CITY OF WESTMINSTER			
PLANNING APPLICATIONS COMMITTEE	Date 28 April 2015	Classification For General Release	
Report of Director of Planning		Wards involved St James's	
Subject of Report	115 Chancery Lane, London, WC2A 1PP		
Proposal	Conversion of upper floors to three residential units with associated external works including the erection of a new roof extension incorporating new windows and a terrace to the rear at fourth floor level new vents to rear elevations to serve internally located air conditioning units, and replacement windows to the front and rear elevations.		
Agent	Planning Potential Ltd.		
On behalf of	Ede & Ravenscroft Ltd		
Registered Number	14/02122/FULL 14/02123/LBC	TP / PP No	TP/21717
Date of Application	06.03.2014	Date amended/ completed	07.04.2014
Category of Application	Minor		
Historic Building Grade	Grade II Listed Building		
Conservation Area	Strand		
Development Plan Context - London Plan July 2011 - Westminster's City Plan: Strategic Policies 2013 - Unitary Development Plan (UDP) January 2007	Within London Plan Central Activities Zone Within Central Activities Zone Central Activities Zone

Refuse permission and listed building consent – loss of historic

PROPOSED THIRD & FOURTH FLOOR PLAN

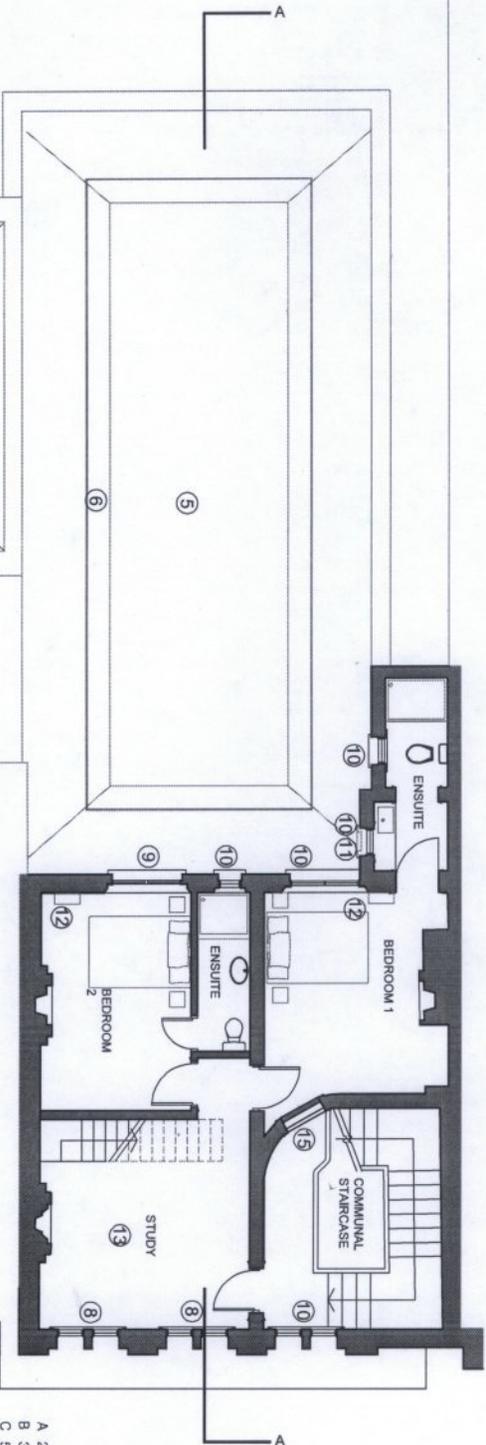
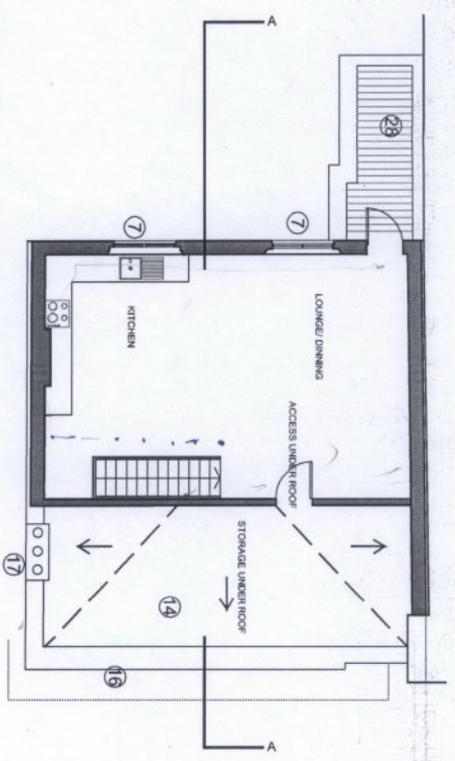
Associated with the provision of a roof extension is the construction of an additional staircase from third to proposed fourth floor level, proposed to be positioned within the front room. The introduction of a stair case in this location is considered to be harmful to the original plan form and internal circulation.

PROPOSED SECTION A-A

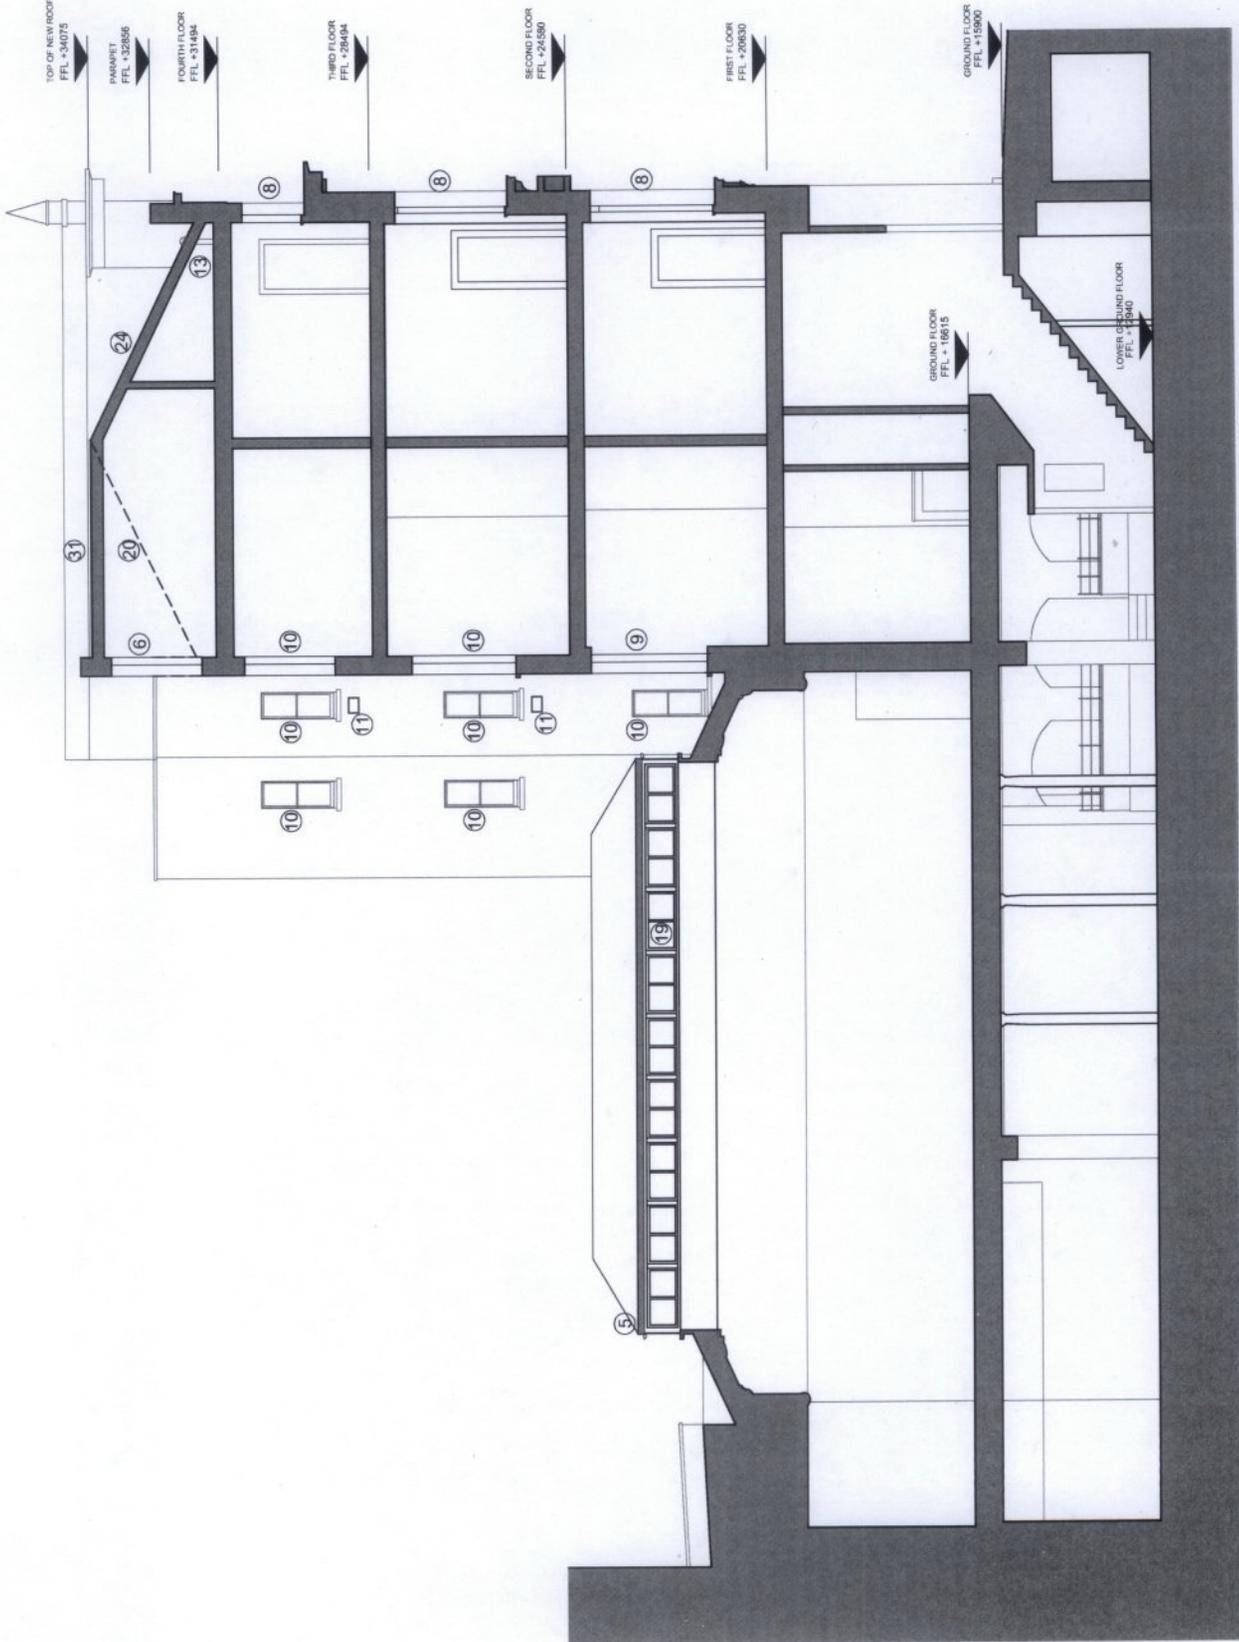
Notwithstanding the principle objection of the loss of the existing roof, the detailed design of the proposed roof extension is also considered unacceptable. The alterations would retain the front pitched section of the original roof but replace the rear section with a vertical continuation of the brick facade to the rear. There are a number of issues arising from this approach, the non-traditional hybrid form and the extension of the rear facade would be visually incongruous and harmful to the original architectural composition of the building. By virtue of its hybrids design and boxy form, the roof would become an incongruous architectural feature of the building, diminishing the building's original form.

Whilst the proposed roof level alterations incorporate an increase in height to the rear, this increase is minimal when viewed in the context of neighbouring buildings. The small roof terrace proposed on the flat roof of the existing rear extension at fourth floor level in association with the top floor duplex flat measures approximately 3.5m². The size and location of the terrace is not considered contentious in amenity terms and does not provide any additional views that cannot already be obtained from existing rear windows of the property.

PROPOSED ROOF PLAN

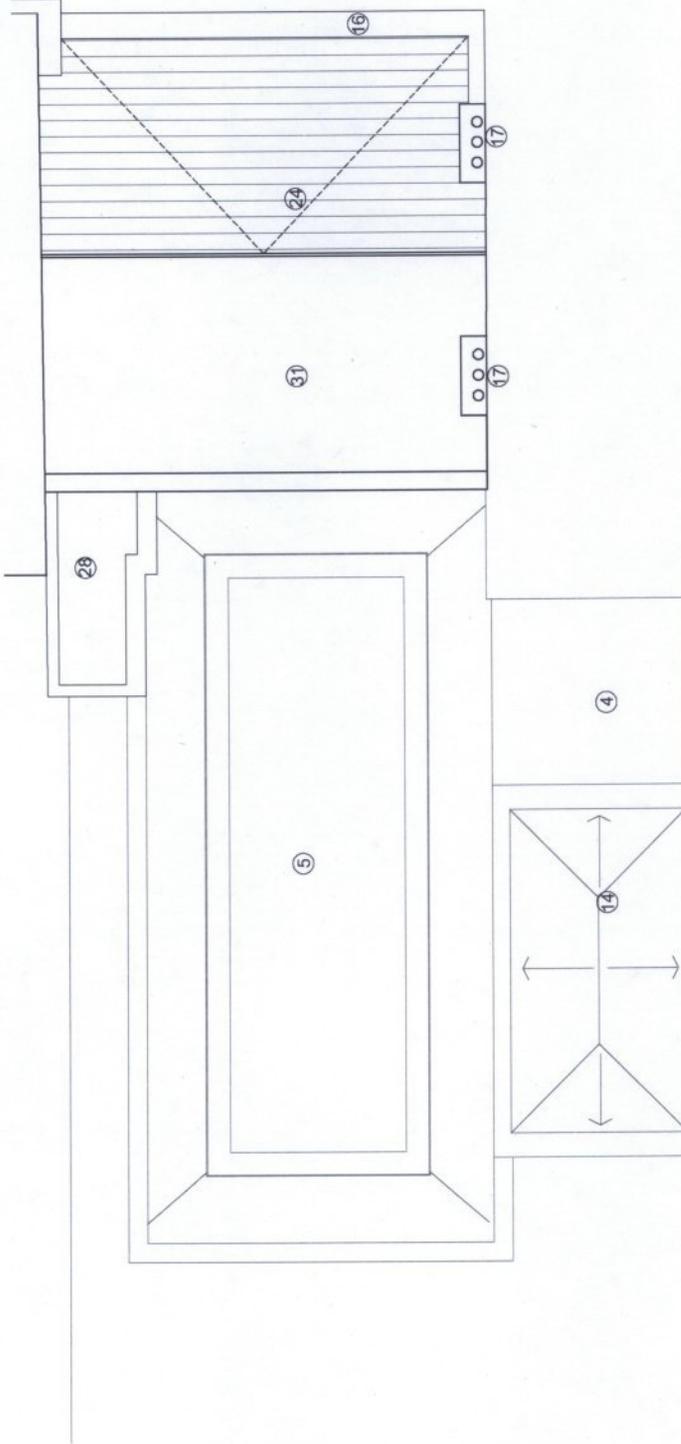
Objection. The loss of the existing historic, hipped roof form is not justified. Its loss would be to the detriment of the architectural integrity of the listed building in terms of its character and appearance. It will cause harm to the special interest of the building.

With regards to the roof extension, the property retains what appears to be an original, if not traditional roof form, which is inherent to the architectural composition and appearance of the building. The loss of the existing roof would be contrary to Policy DES6: Roof Level Alterations and extensions, which states that permission will generally be refused for roof alterations where the proposals seek the loss of a roof of historic significance.
